Re: Approval of Temporary Certificate of Occupancy (C.O.) for
Albuquerque Studios Bldg 2 (only), [R-16 / D2]
5650 University SE
Architect's Stamp Dated 01/23/07

**Re: Temporary C.O. Albuquerque Studios
Building 2 and Building 3 (stage area only)
5650 University Blvd. SE Albuquerque, NM 87106**

SITE DEVELOPMENT PLAN

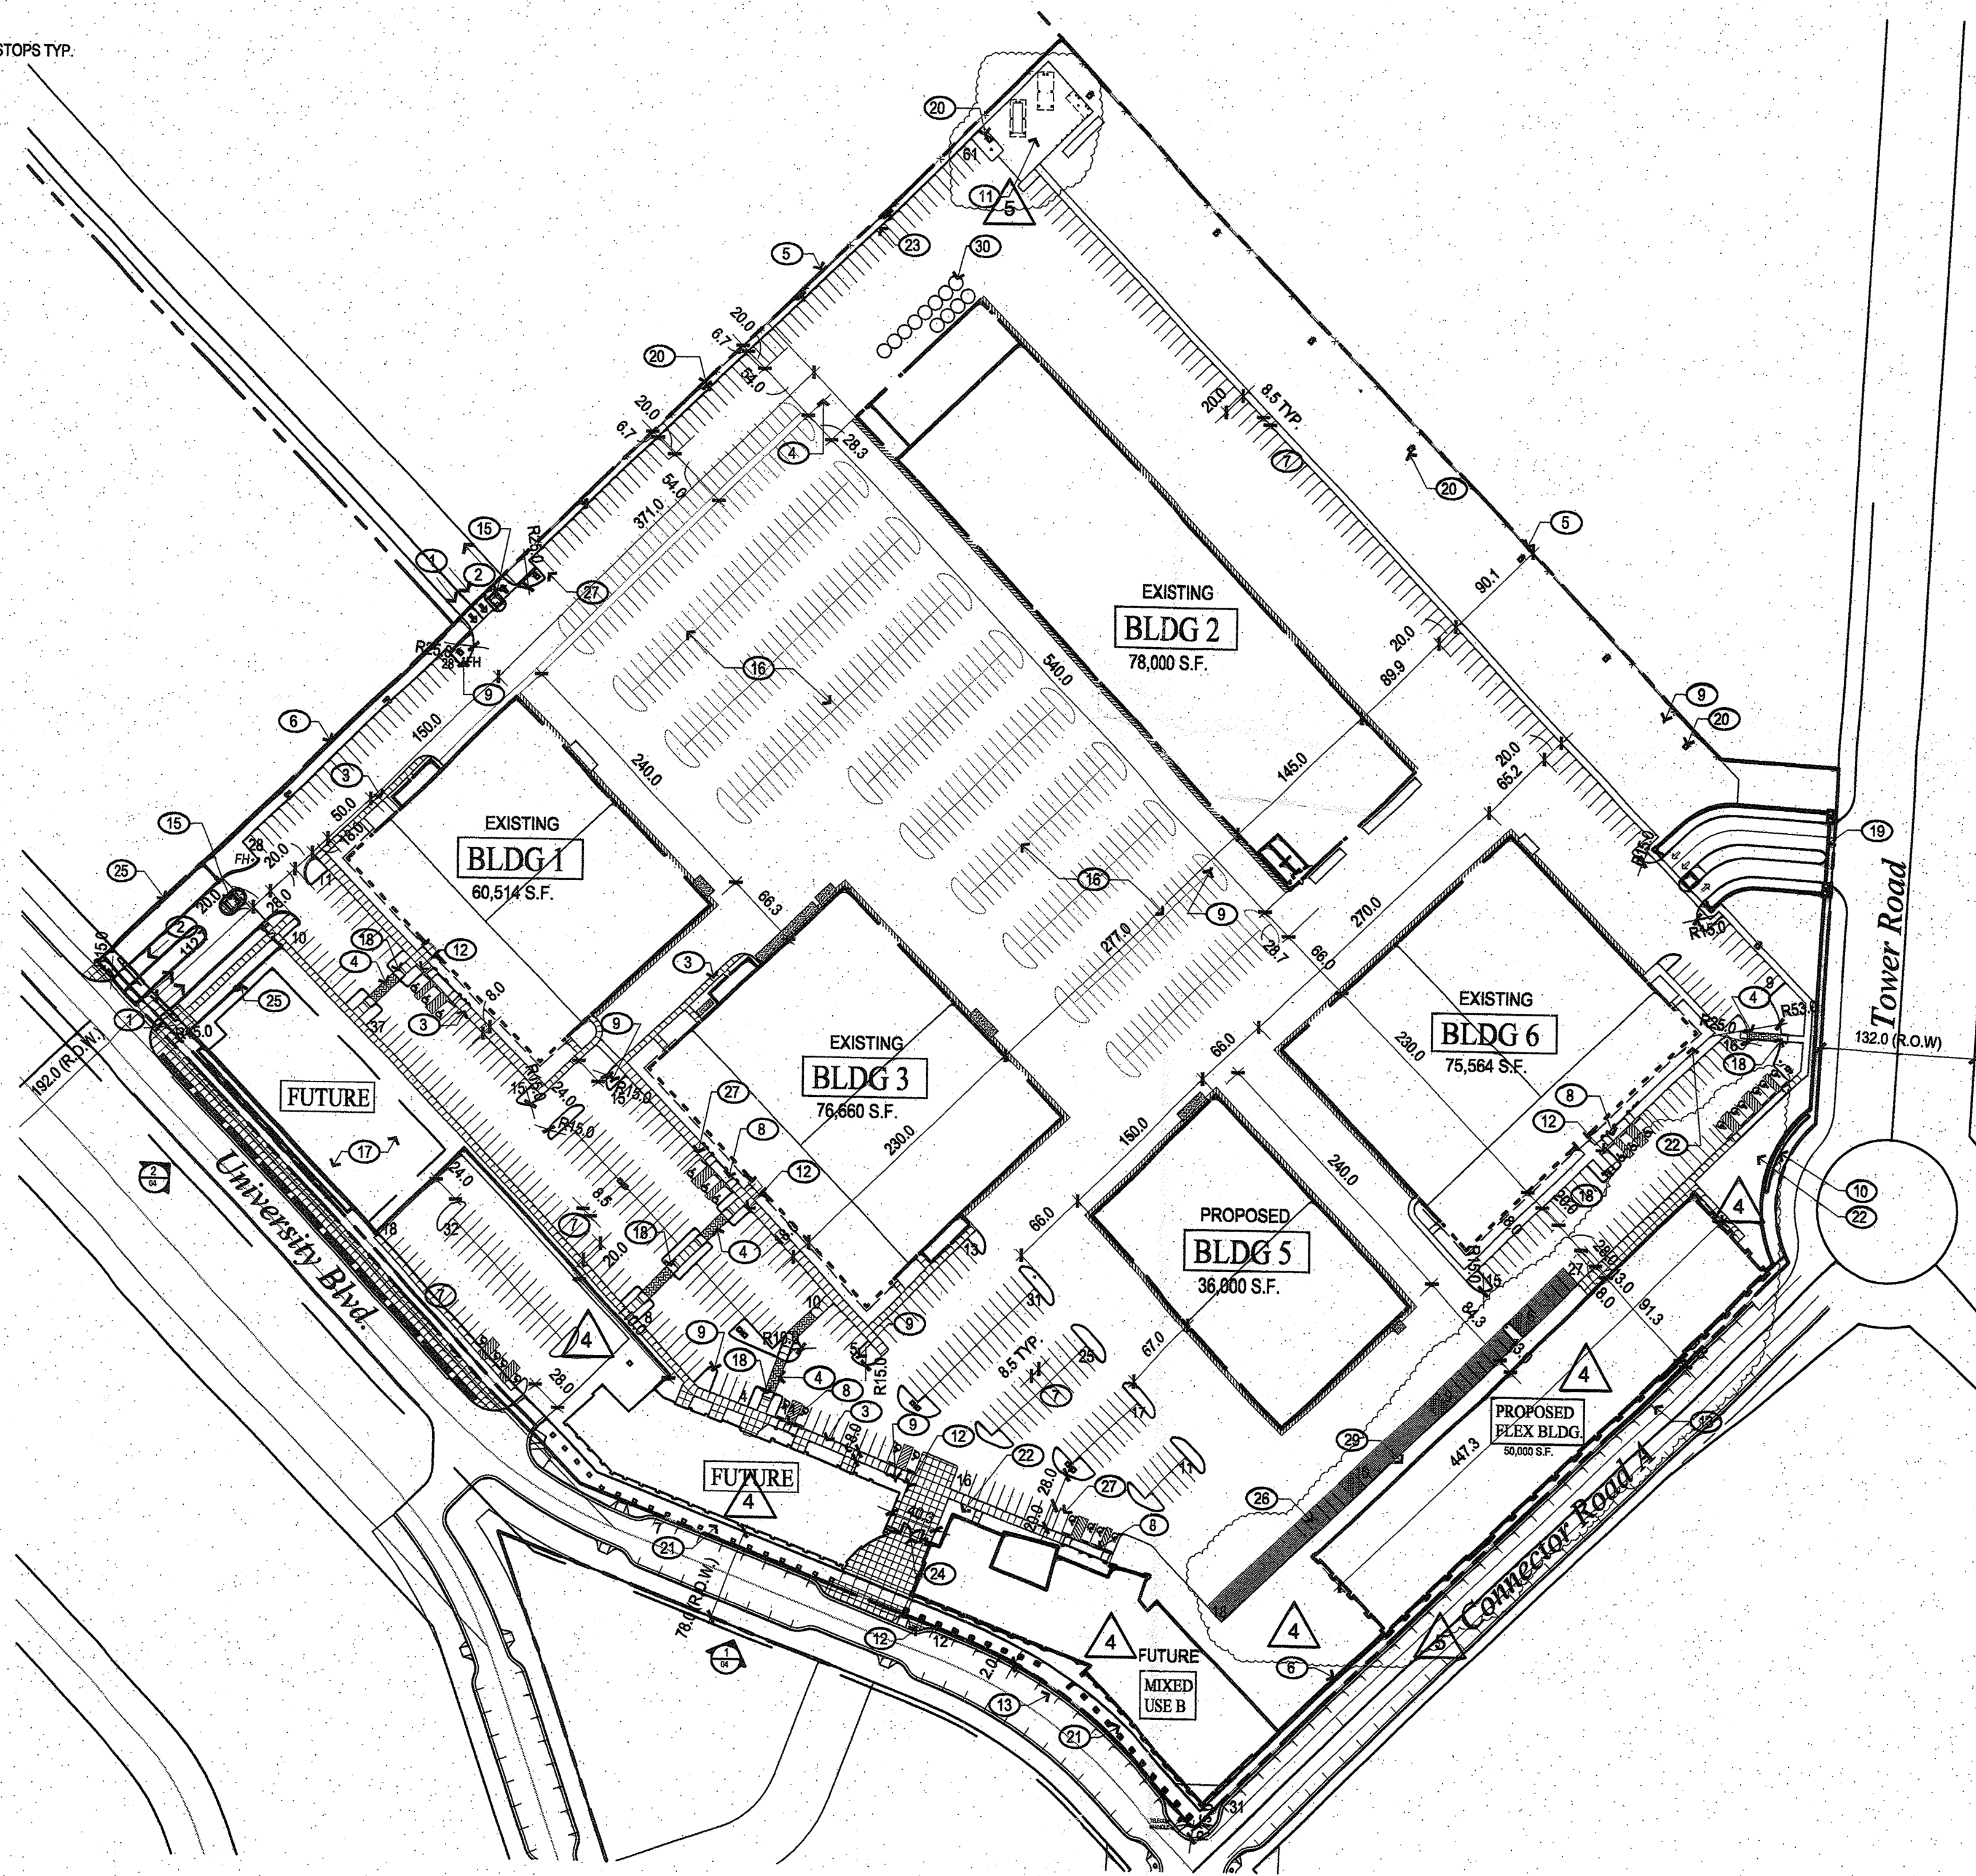
1. The 2-story office portion of Building 3 is still under construction and shall not be finished for another week.
2. Buildings 1 and 6 are still under construction at different levels of completion.

3. Building 5 and both mixed use buildings are not being built at the present time and shall be constructed at a latter phase.
4. Parking lot striping has just begun on the northeast side of Building 2 and shall continue for possibly several weeks.

5. The entire area around Building 1 is not paved and shall not be until the building is at a further level of completion.
6. The curb work at both the northwest and southeast sides of the Building 2 was not constructed and was paved right up to the face of the building. All utility equipment located in these areas is currently having steel bollards installed.

7. The sidewalk in front of Building 3 was redesigned because the pavement was installed 2 inches too high for a portion of the walkway at the main entry. To accommodate the change, the sidewalk ramps down at the accessible parking area extends past the entrance island, and then ramps up again about 13 ft. past the entrance. Pre-cast parking bumpers will be provided as wheel stops at the parking spaces that are flush with the sidewalk.

8. Parking end caps along the front and side of Building 3 are currently being formed.
9. The concrete sidewalk and curb was extended too far on the southeast side of Building 3 and shall be corrected to show the proper parking layout shown in the attached AA.

10. The parking lot and refuse enclosure along Connector Road 'A' has not been constructed. This area will be built when Connector Road 'A' is built.
11. The entry to the Studios along University Blvd. has not been built. The extension of University Blvd. is currently underway and the entry shall be constructed when the extension is at a further level of completion.

12. A temporary 6" asphalt curb runs along the parking area at the northeast side of the site adjacent to Building 2.

13. Temporary access to the site is at the northwest side entrance. A temporary guardhouse is located there with chain link gates. A 2-way gravel road leads up to this entrance that originates at the north side of the current Advent building.
14. The site is totally enclosed within a temporary 6'-0" high chain link security fence along the perimeter. The portions of the site associated with Buildings 2 and 3 are separated from the remainder of the site with a temporary 6' chain link fence.
15. A portion of the site on the northeast side of Building 6 is not paved at this time, but shall be as that building is completed.

Based on the information provided on your submittal dated January 23, 2007, the above referenced project is approved for a 90-day Temporary C.O.

A Temporary C.O. has been issued allowing the outstanding infrastructure construction and striping issues to be completed within this time period. When these remaining issues have been fully completed, are in substantial compliance, and a final Certification for Transportation has been resubmitted to the City's Hydrology office for approval, a Permanent C.O. will be issued.
